Homebush Bay Bridge | Environmental Assessment

## APPENDIX E

Government authorities  
and public utility providers  
consultation meeting minutes  
and correspondence

## Government authorities and utility providers consultation records

DIAGRAM SHOWING  
BRIDGE LANDING ZONE  
ON RHODES FORESHORE

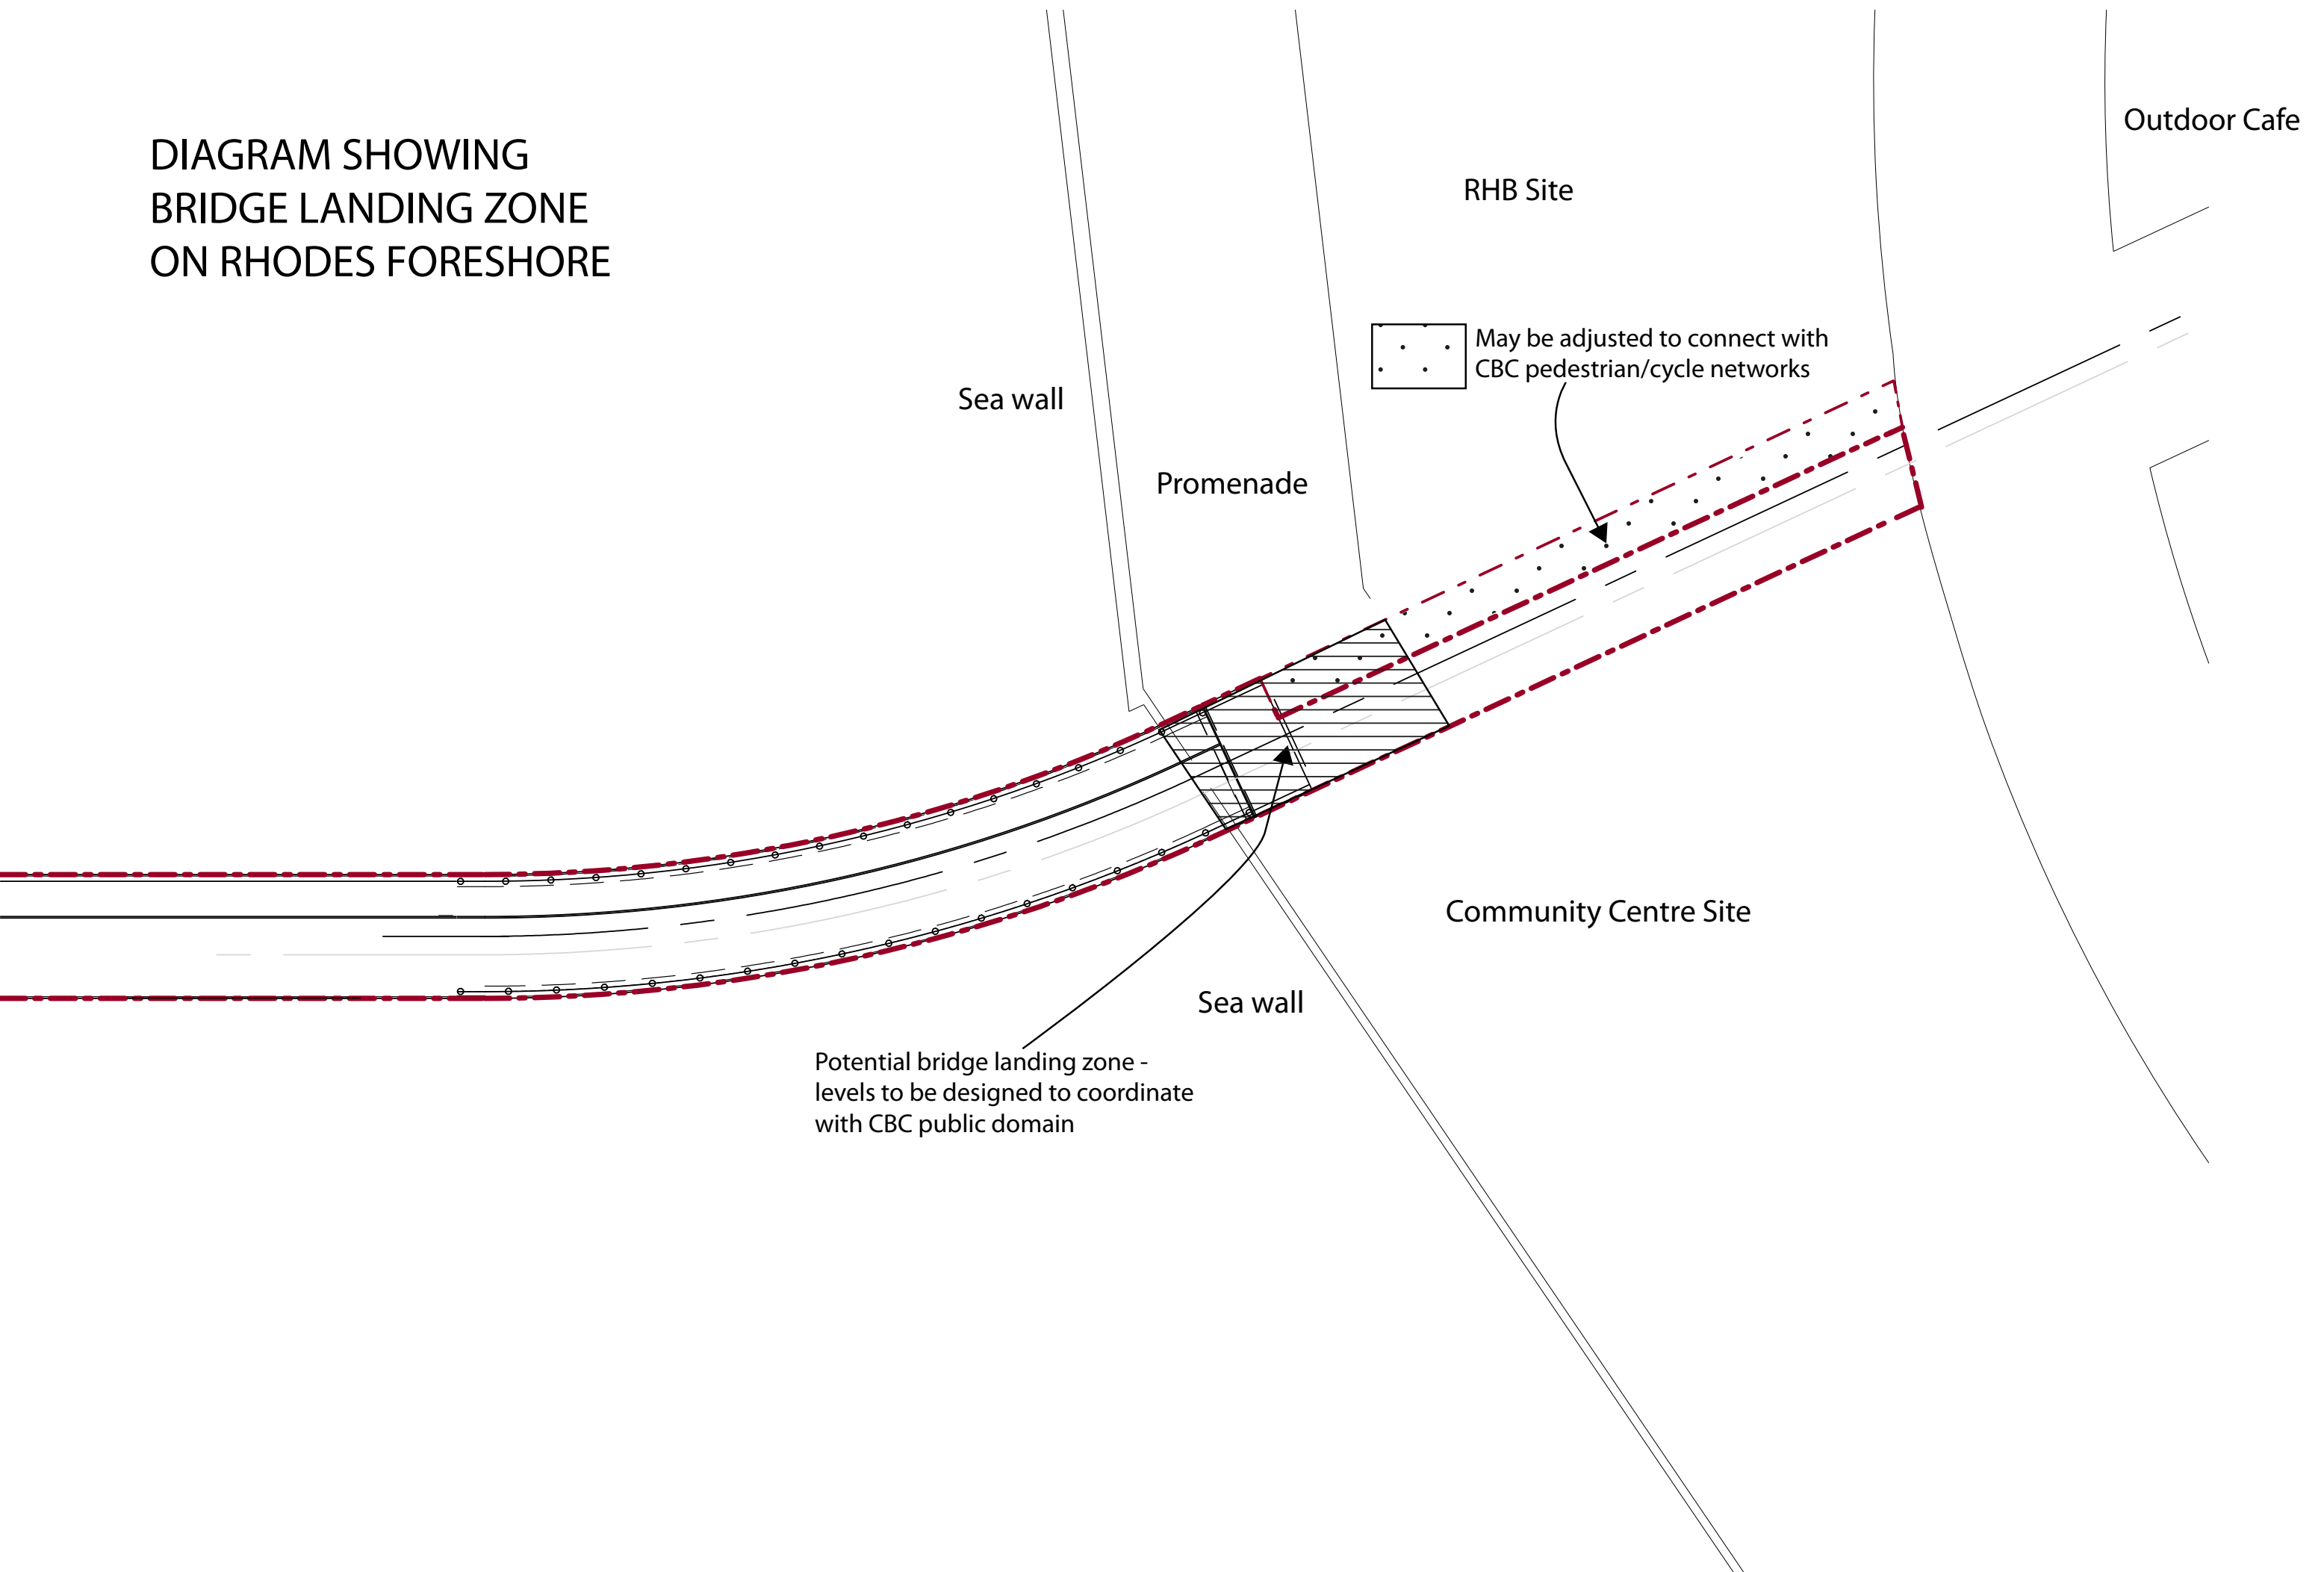
- Council would like its Community Centre and forecourt area to be the focal point of the Rhodes Foreshore, and not the proposed Bridge abutment. This should be reflected in the urban design and landscape treatments of all areas around the Bridge landing.
- The Community Centre floor level will be the Probably Maximum Flood (PMF) flood level plus 500 mm freeboard. The Community Centre will have two levels.

- Council would expect the developer to raise and strengthen the seawall at the abutment and the ramps to accommodate the Bridge levels. This will ensure that Council will not have to fund bridge abutment protection measures in the future, arising from sea level rise due to climate change.
- The Bridge abutment shall be immediately behind the seawall to minimise the Bridge's occupation of the Foreshore Park and Community Centre forecourt. This will allow Council's Foreshore Park and Community Centre forecourt to be designed without the constraint of the Bridge abutment, terminals, fencing and traffic barrier rails.

- Council's comments regarding disabled ramps, adjusting levels and strengthening seawalls and undertaking landscaping are based on a misunderstanding of the sketches and diagrams of the landing (June 2011). These plans were prepared simply to illustrate issues rather than to propose a solution. As Council and the developer have agreed to collaborate on the preparation of the respective designs of adjoining areas, these interface works will be eliminated. The plan now attached illustrates the potential Bridge landing zone within which the Bridge termination may occur in order to coordinate with Council's preferred levels.

- The Bridge termination is able to be designed anywhere within the landing zone to suit and coordinate with Council's design for the public domain. The Bridge designers will collaborate with Council on setting these preferred levels to ensure that any abortive works are avoided and any interface works are minimised.

Figure 1 SK01 Workshop Illustration\_potential design speeds

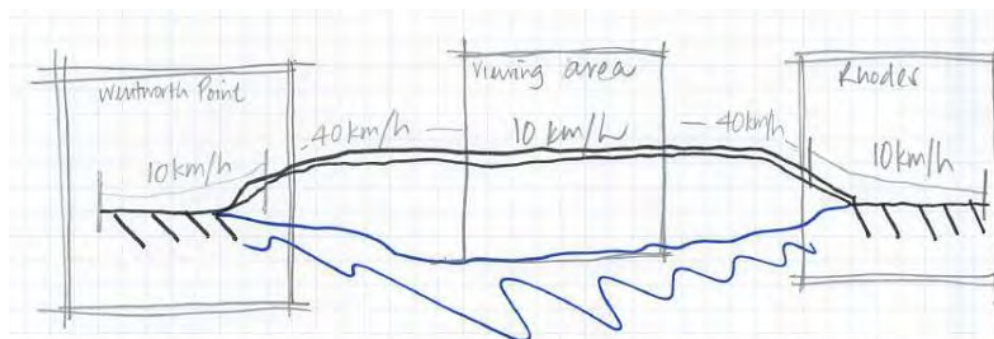
- RTA advised that a 10km/h design speed is required for shared zones and is only appropriate to self enforcing environments such as short laneways in built up urban areas.
